CALL NO. 404
CONTRACT ID NO. 252113
ADDENDUM # 2

Subject: Henry-Shelby Counties, 121GR25P036 - FD05
Letting July 24, 2025

DESCRIPTION KY 22 & US 421 HENRY COUNTY & US 421 SHELBY COUNTY

WORK TYPE ASPHALT RESURFACING

SUBSECTION: 03.13 Loop Installation.

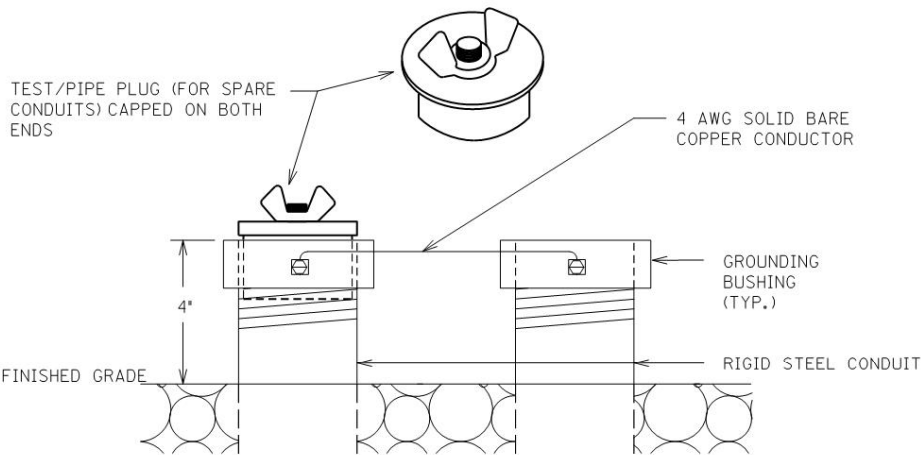
Contrary to section 723:

REVISION: Replace first sentence note with the following:

twist unshielded loop wire (imsa 51-7) with 3 to 5 turns from the start of homerun to the inside conduit, junction box, cabinet, or pole. Twist unshielded loop wires (imsa 51-7) with 3 to 5 turns per foot from the start of the homerun to the junction box, cabinet, or pole. Slot can be widen to .5" to .625" to help with the installation of the twisted wire.
